RENESAS TECHNICAL UPDATE

Product Category	User Development Environment		Document No.	TN-EML-112A/EA	Rev.	1.0
Title	Correction of Errors in the H8S Family E10A Emulator Additional Document for User's Manual Specific Guide for the H8S/2114F E10A Emulator		Information Category	Correction or Supplement of Document		
Applicable Product	H8S/2114F E10A Emulator HS2114KCM01H HS2114KCI01H	Lot No.	Reference Document	H8S Family E10A Emulator Additional Document for User's Manual Specific Guide for the H8S/2114F E10A Emulator (REJ10B0102-0100H, Rev.1.0)		
		V1.0.00

Please note that there are errors in the H8S Family E10A Emulator Additional Document for User's Manual Specific Guide for the H8S/2114F E10A Emulator (REJ10B0102-0100H, Rev.1.00), which must be corrected as listed below.

Figure 1.3 Example of Emulator Connection

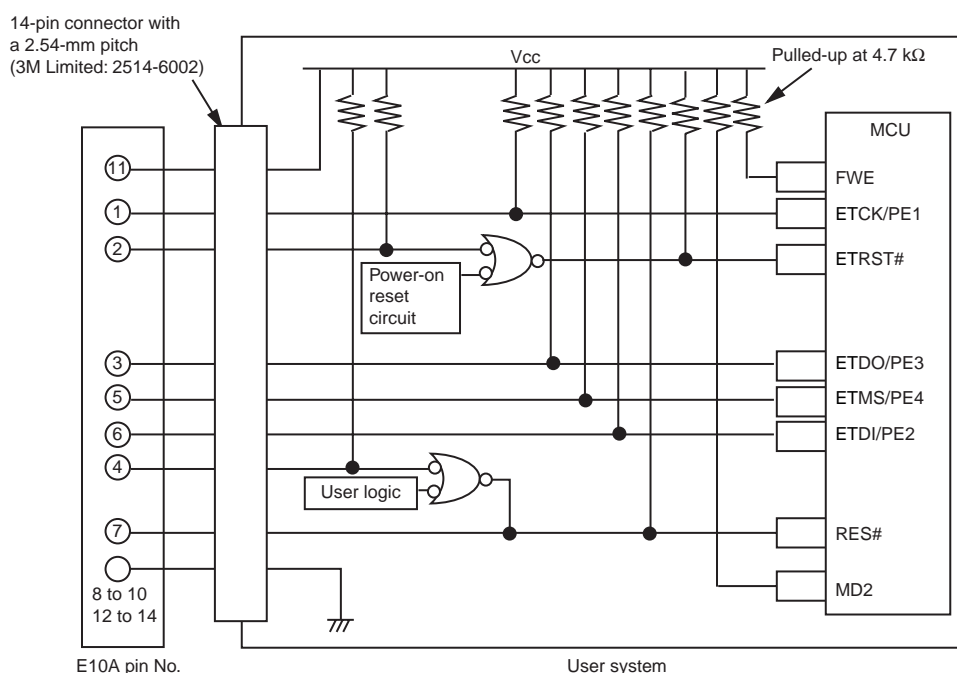
Correction 1: Figure 1.3 in page 4

(After change)

Pull up the MD2. For details, see figure 1.5 shown in the next page.

· RES# of pin 4 of the H-UDI port connector is a signal line in which the E10A emulator outputs signals to the MCU. An AND operation must be performed between RES# (pin 4) and the user system reset circuit for the signal line connected to the MCU.

· RES# of pin 7 of the H-UDI port connector is a signal line in which the E10A emulator monitors the RES# signal of the MCU. The RES# must be pulled up before it is connected to pin 7 of the H-UDI port connector.

Figure 1.5 Emulator and Pin MD2

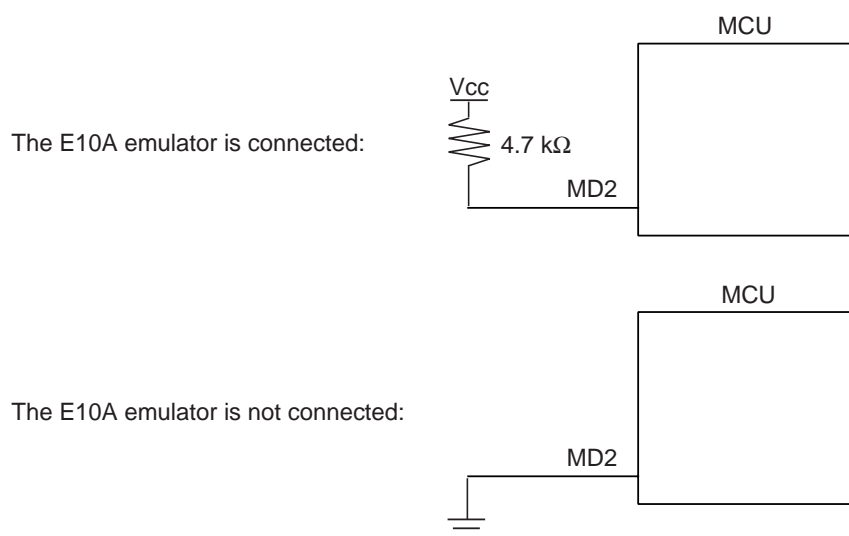
Correction 2: Note 2 in page 5

(Before change)

The MD2 pin of the H8S/2114F must be pulled up when not connecting with the E10A emulator, and connected to ground when connecting with the E10A emulator.

(After change)

If the emulator is not connected to the user system, ground pin MD2 of the MCU. When the emulator is connected to the user system, pull up the MD2.
